CONGRESS SQUARE REDESIGN STUDY GROUP

Memorandum
Planning and Urban Development Department
Planning Division

Re: Congress Square Plaza proposal assessment

Meeting Date: Wednesday, May 22, 2013

Diagram 1
 Total Area of Plaza
 NTS

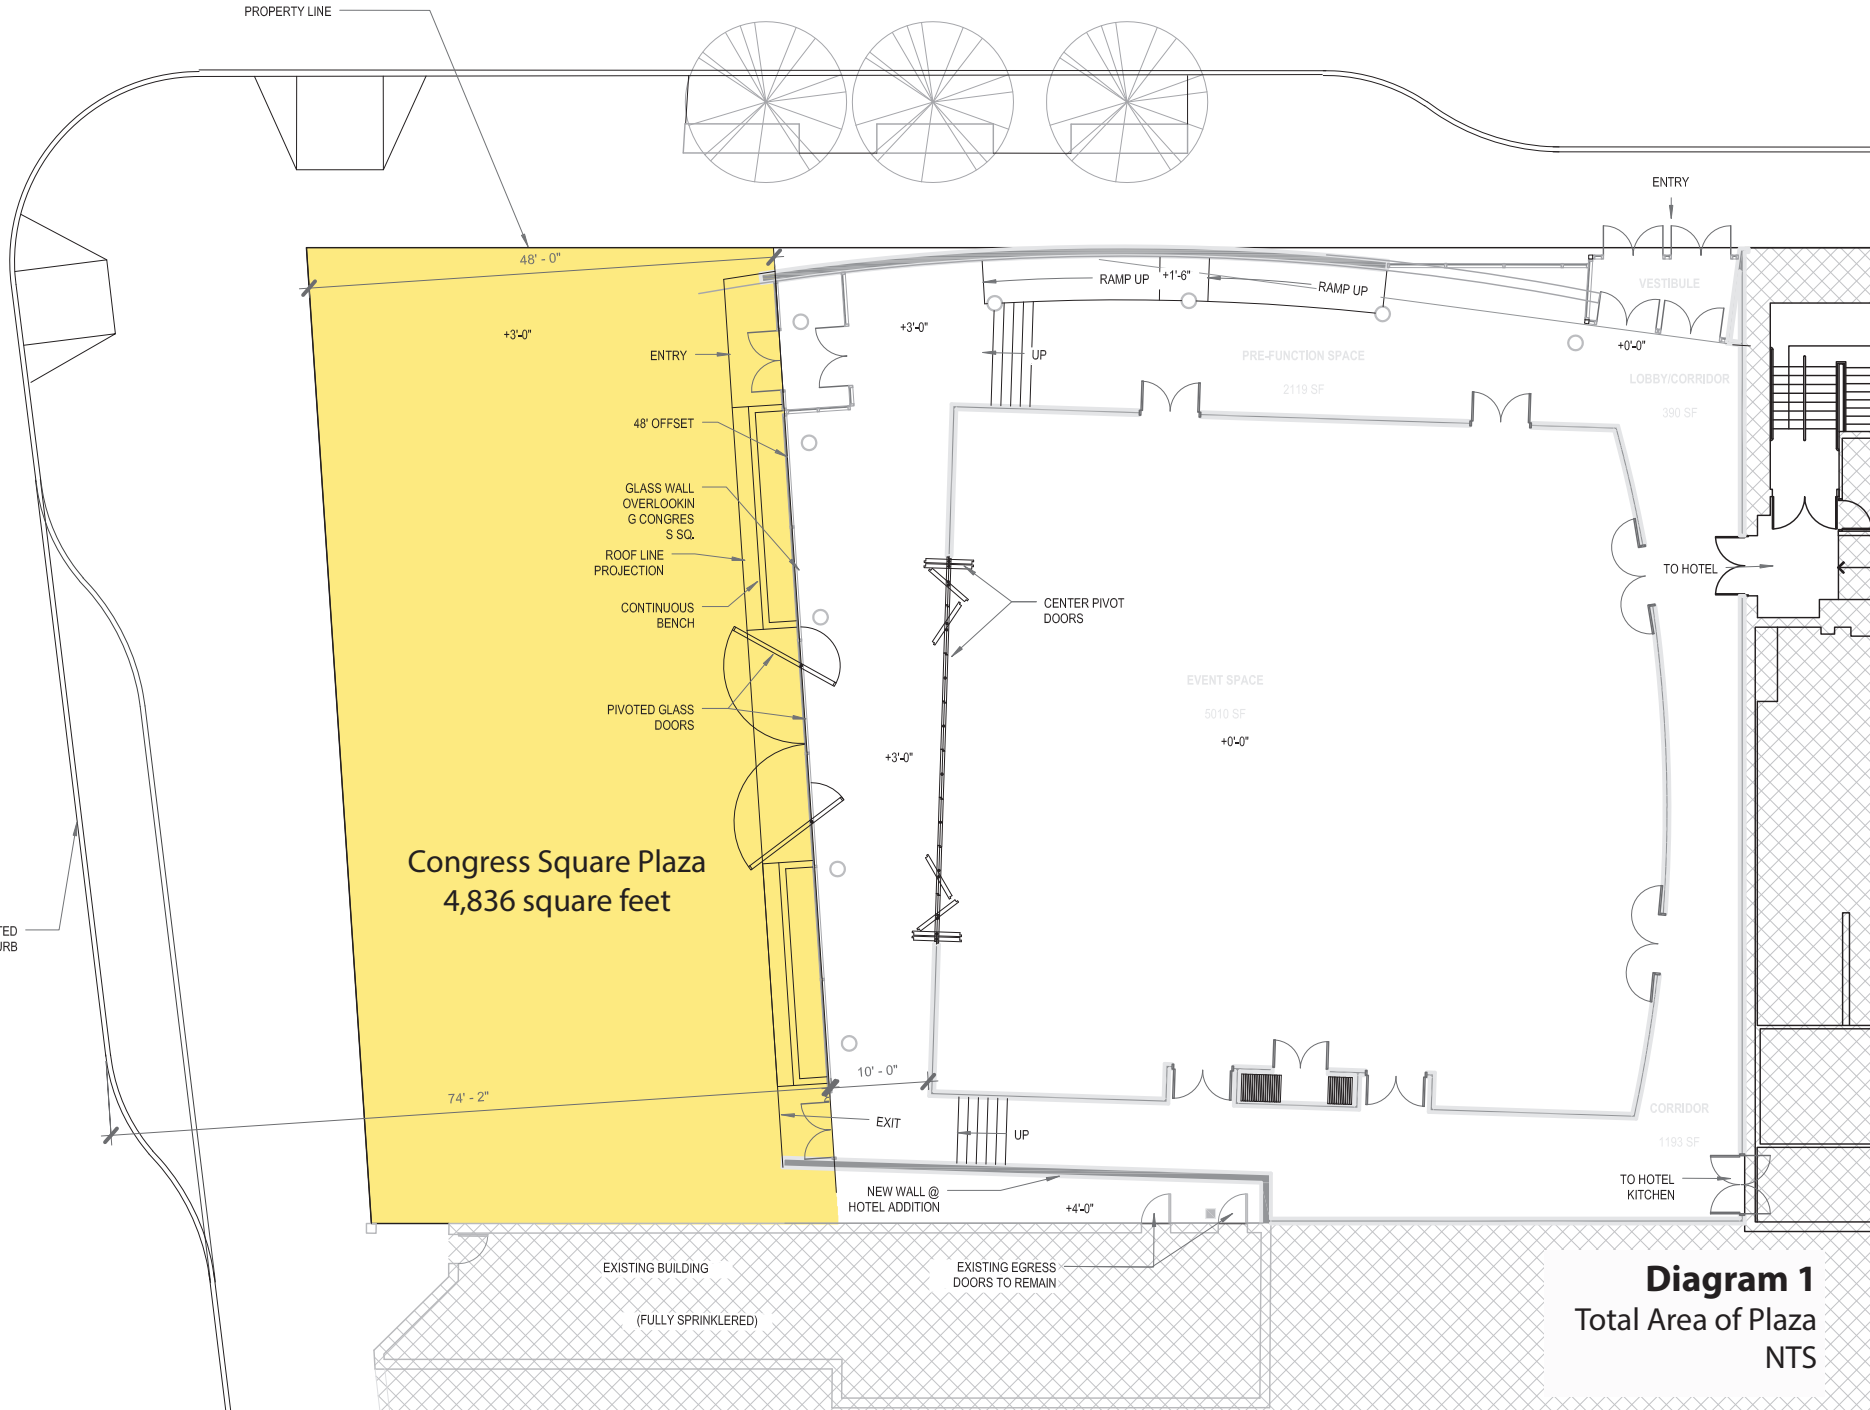
- a) **Dimensions:** Minimum area is **2,000 square feet**

Meets Requirement: Proposal is for 4,836 square feet (Diagram 1)

Diagram 2
 Configuration: 40 foot depth
 NTS

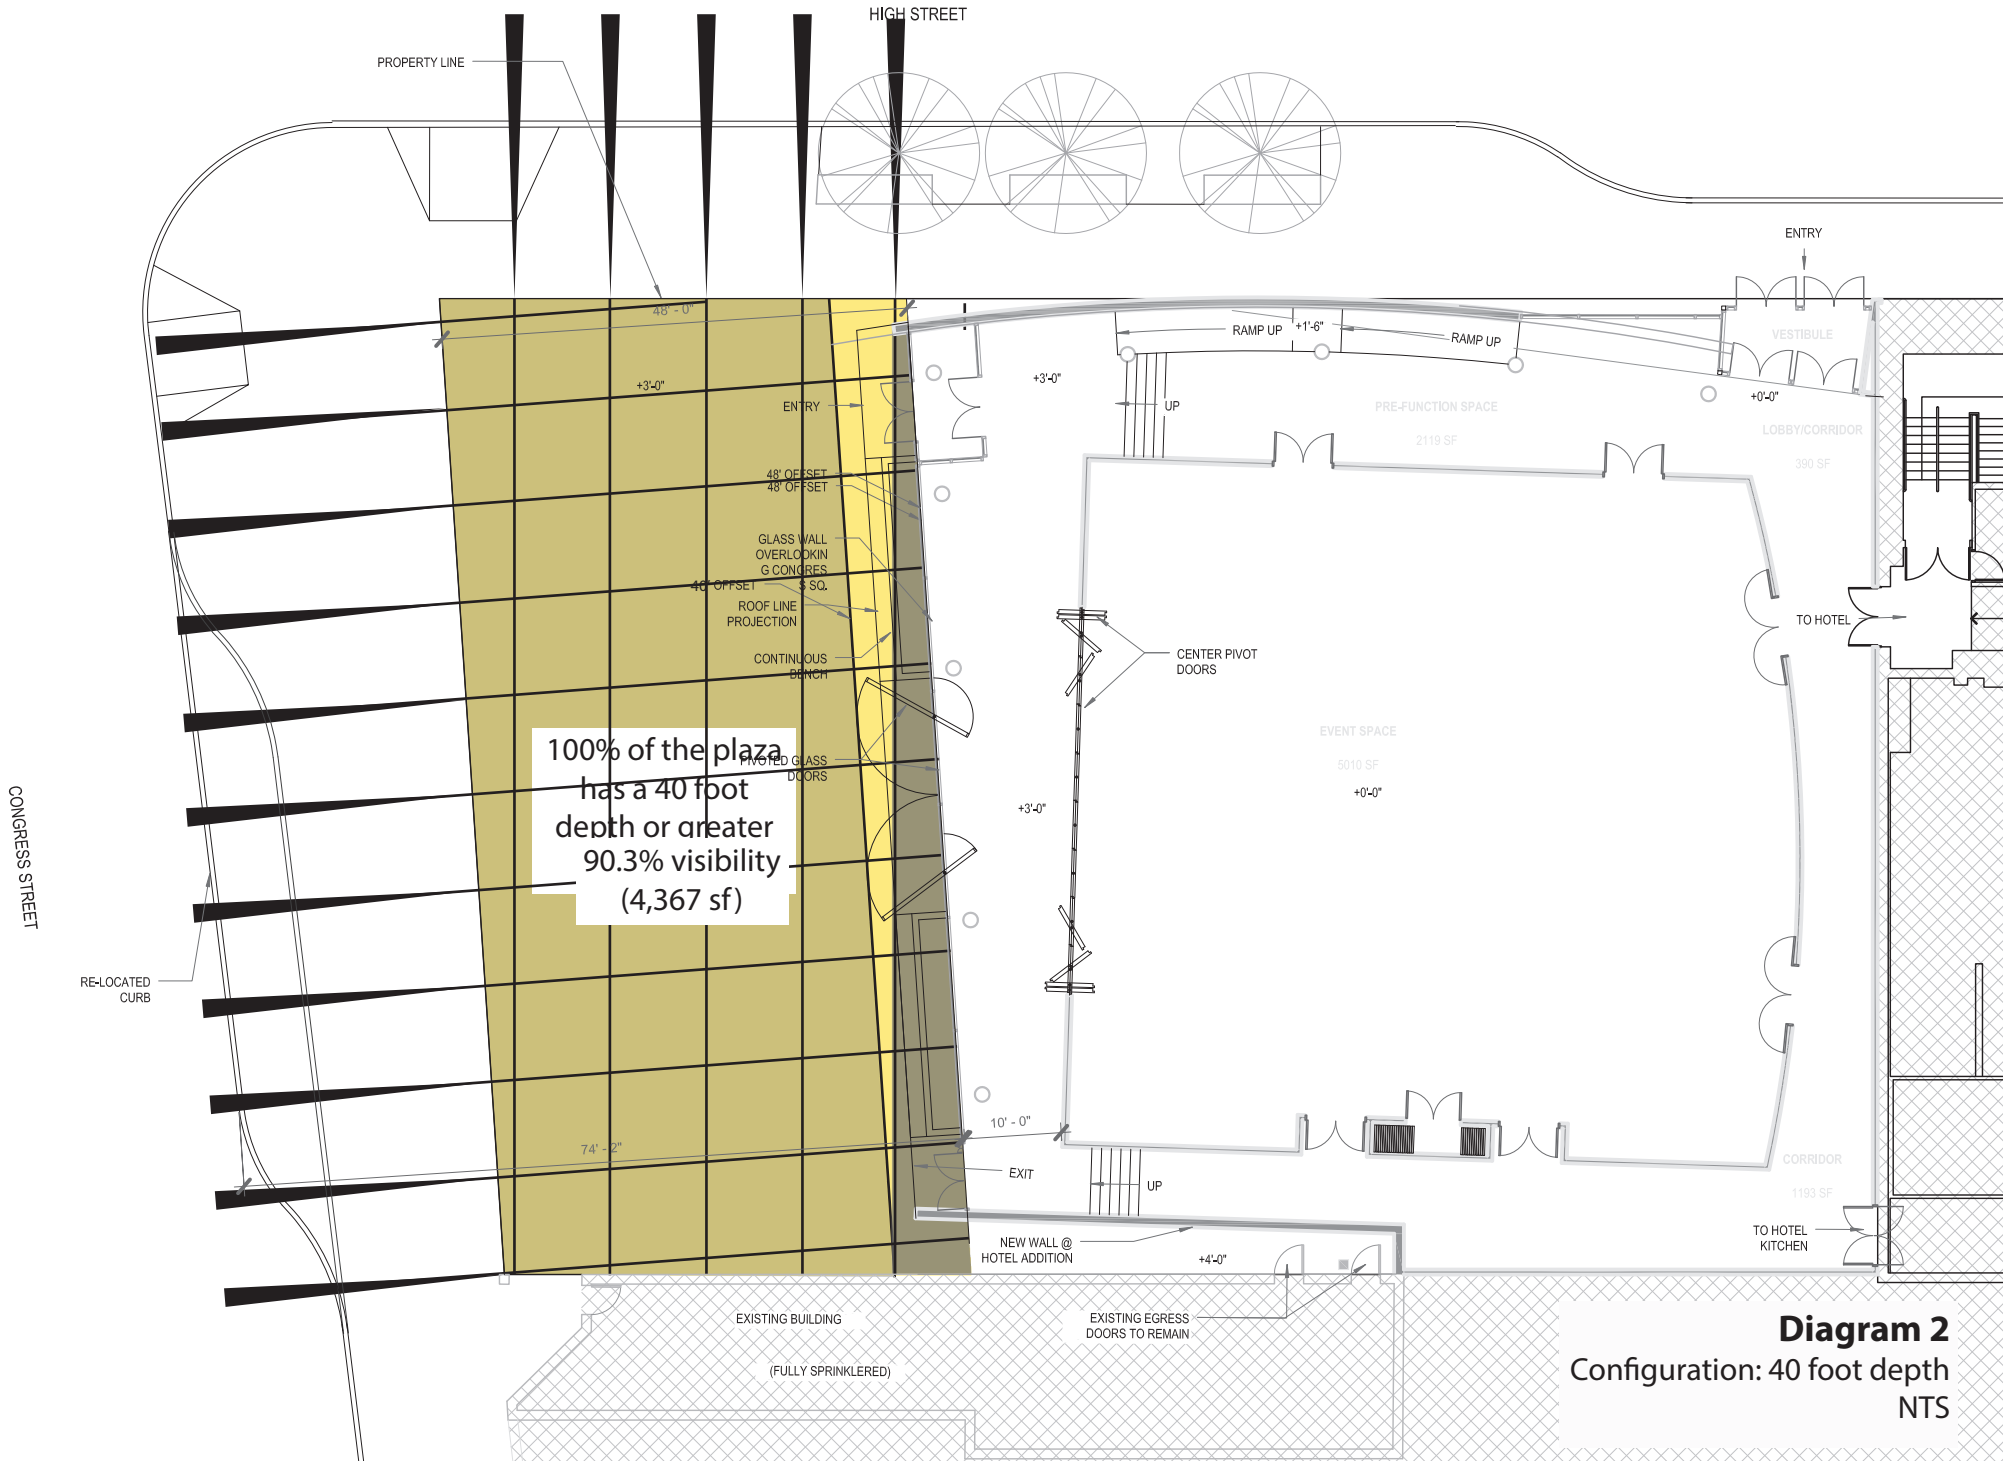
- b) **Configuration:** Major portions of public plazas are required to have average width and depth of **40 feet**. Up to **20%** of the plaza area may be less than 40 feet in depth.

Meets Requirement: The entire area of the plaza is set back 48 feet from the property line and therefore meets the 40 foot depth requirement for 100% of the park area. (Diagram 2)

Diagram 3
 Visibility: 50% from street
 NTS

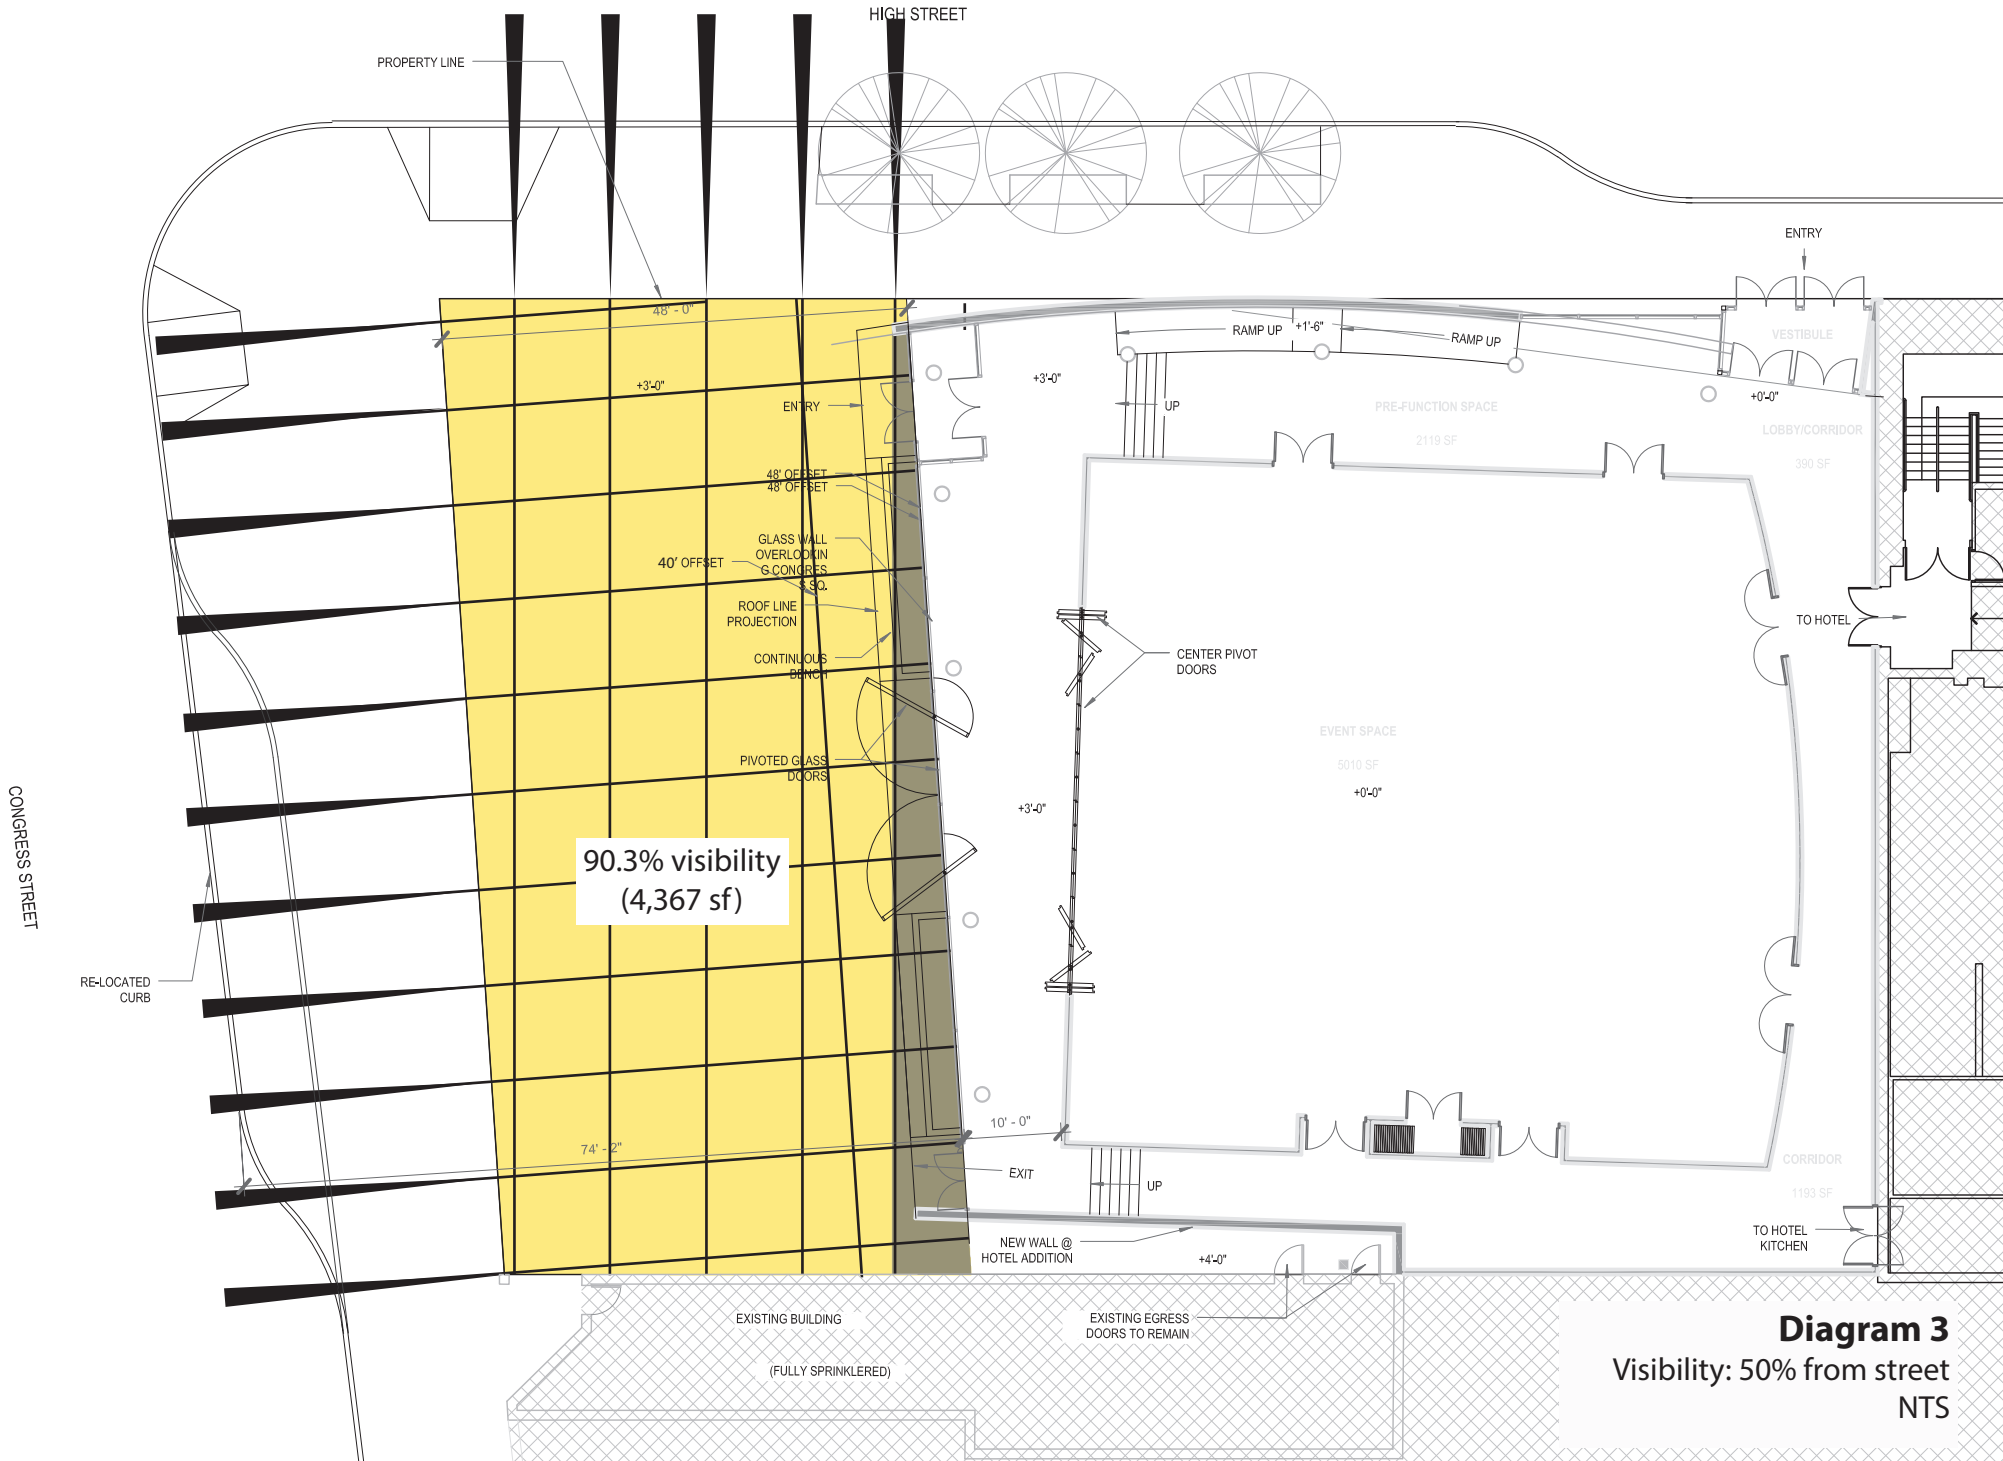
- e) **Visibility:** Public plazas are required to be completely visible when viewed from any adjacent street frontage. To maintain design flexibility for plazas that are located on corners where streets do not meet at 90 degree angles, the visibility requirements only require complete visibility from one street frontage and at least **50% visibility** from the other street frontage.

Meets Requirement: The proposal does not have streets at right angles and therefore is subject to the 50% visibility minimum which it meets at 90.3% visibility from the street frontage as demonstrated in (Diagram 3).
